**Rockaway Park Former Manufactured Gas Plant (MGP) Site
Rockaway Park, Queens County, New York**

April 24, 2009 Field Change Request: FCR-02a

Waterloo Barrier Installation Procedures

Waterloo Installation
Procedure

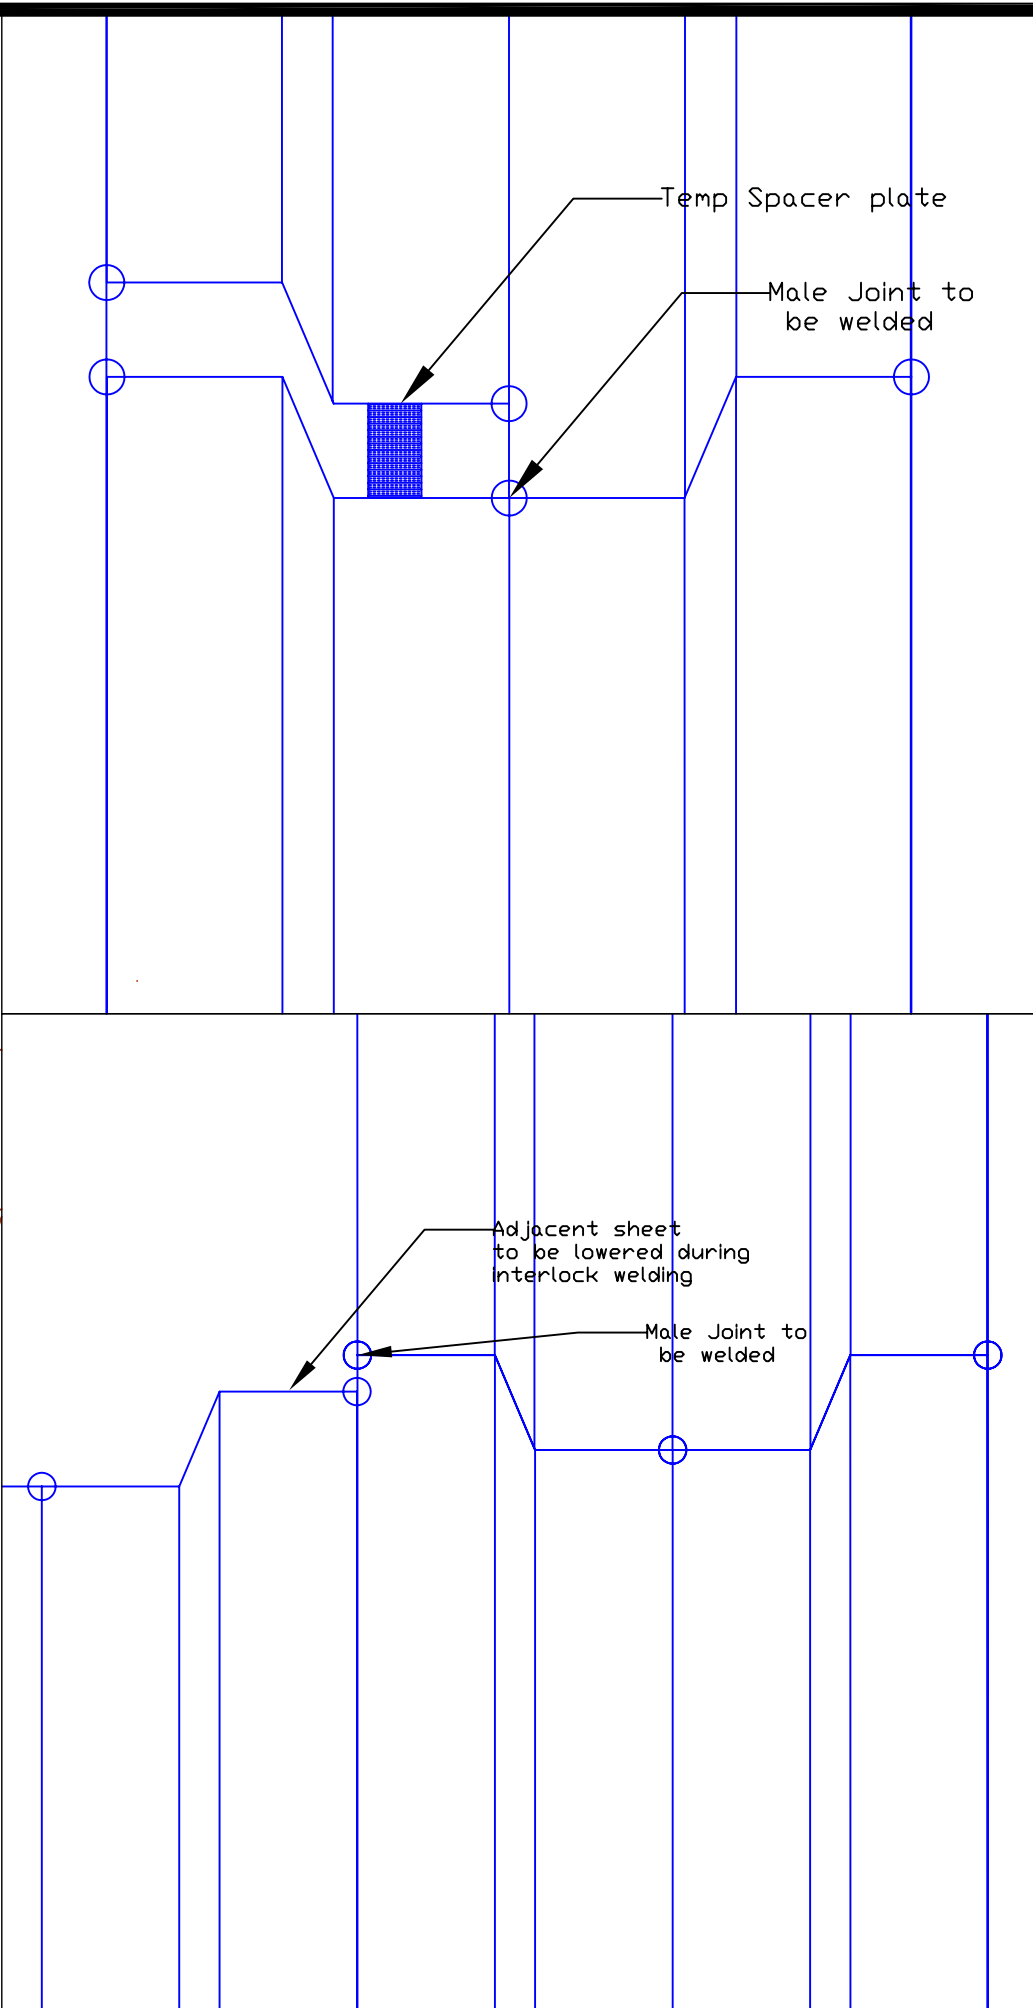
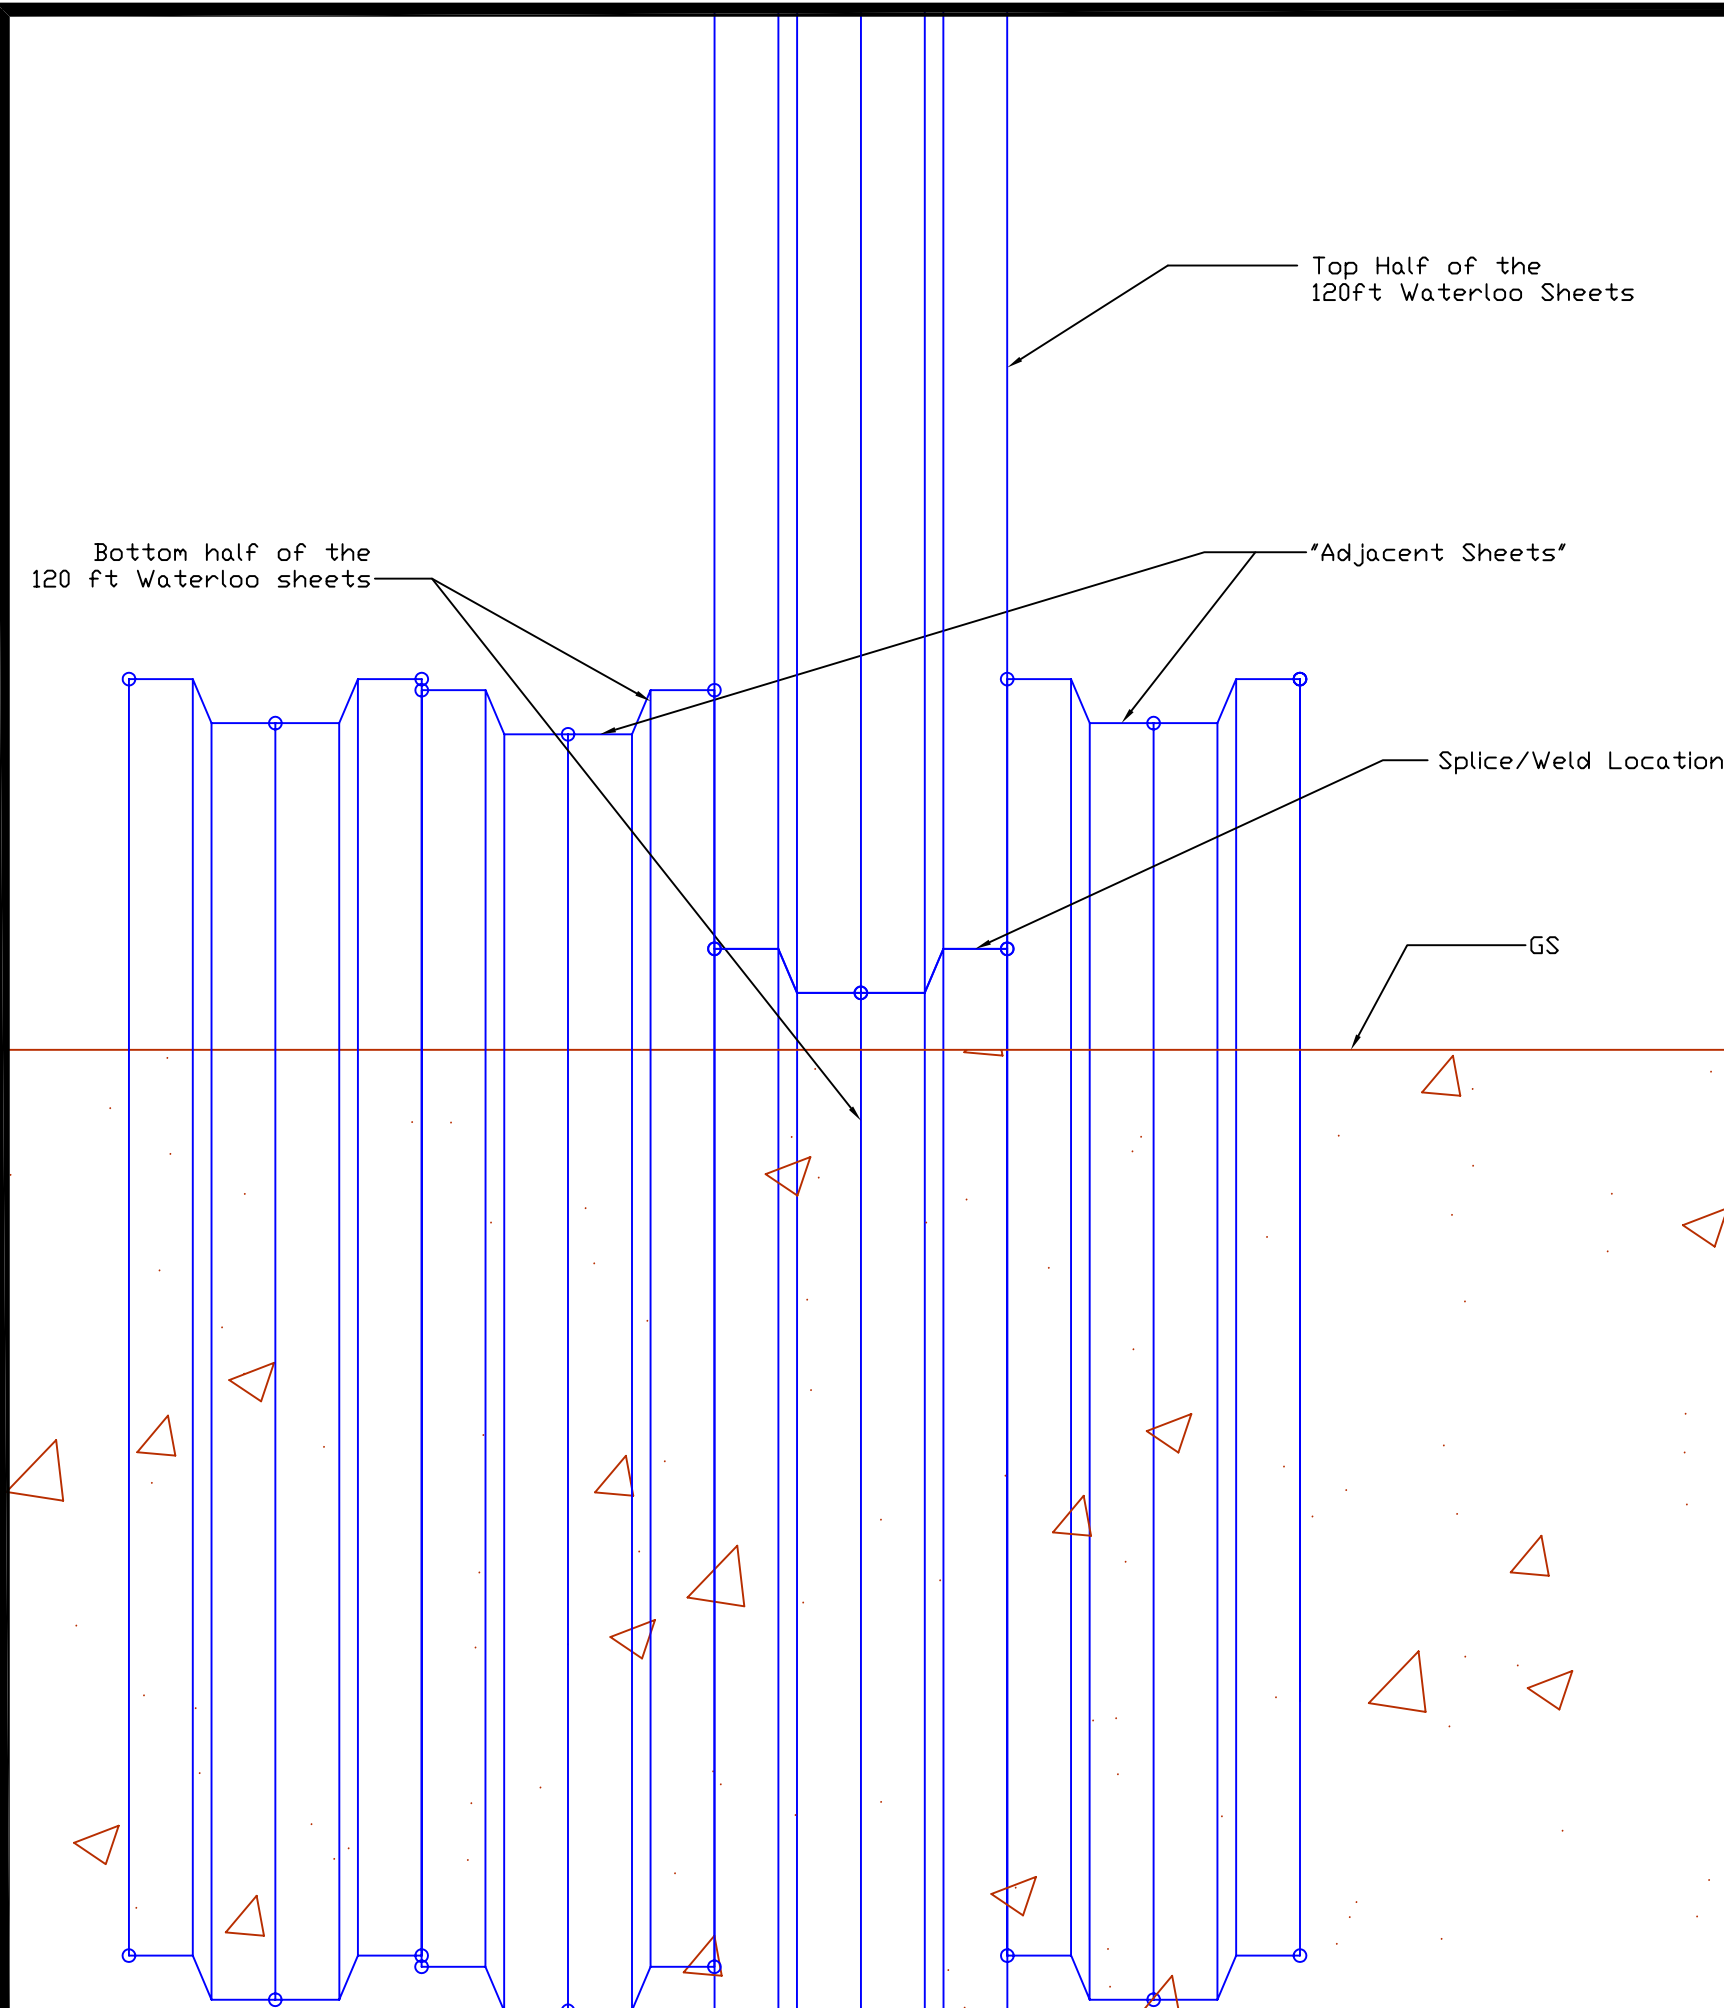
Posillico's Installation Procedures for the top half of the 120 foot long On-Site Area DNAPL Migration Barriers are presented in the attached document entitled "April 23, 2009 Installation of the Top Half of the Waterloo Barrier (refer to Attachment A)." In summary, the Waterloo Barrier Installation Procedures have been updated where a lattice boom crawler crane and a variable moment vibratory hammer will be utilized to install the steel sheet piles instead of the ABI Mobilram and vibratory hammer. The steel sheet pile will remain attached to the lattice boom crawler crane and the variable moment vibratory hammer assembly until the pile installation is completed.

Please refer to the attached diagram and written procedure.

- 1) Once the bottom half of the 120 ft Waterloo sheet piles are driven to approximately 10ft above grade, the crane will be rigged to pick up the top half of the sheet pile using the secondary jib.

- 2) The crane will then lift the sheet pile using the secondary jib to a height sufficient enough to thread the top half of the sheet into the interlocks of the two adjacent sheets.

- a. A small piece of steel (roughly 4" x 1/2" x 4") will be placed between the leading half sheet and bottom sheet to allow for the full welding of the male interlock.

- 3) Once the sheet is fully interlocked into the two adjacent sheets, the crane will hold the sheet in place with the secondary jib while the bottom of the sheet is welded to the top of the previously driven sheet.

- a. Once the first half of the sheet pile is fully welded, (including the male interlock) the leading half of the sheet will be picked up so that the small piece of steel can be removed from between the top and bottom half sheets.

- b. Once the second half of the sheet (leading sheet) is completely welded, with the exception of the leading male interlock, the adjacent sheet pile will be driven so that the top of the sheet is a few inches below the splice location of the sheet being welded to allow for the complete welding of the leading male interlock.

- 4) At this point, the two 60 ft sheet piles are fully welded into one contiguous 120 ft sheet pile, allowing the secondary jib of the Crane to be detached from the top of the sheet.

- 5) The Crane will then lower the Variable Moment Hammer onto the sheet with the main jib, and drive the 120 ft sheet pile either to grade, or to a height that will facilitate the threading of the adjacent sheet.
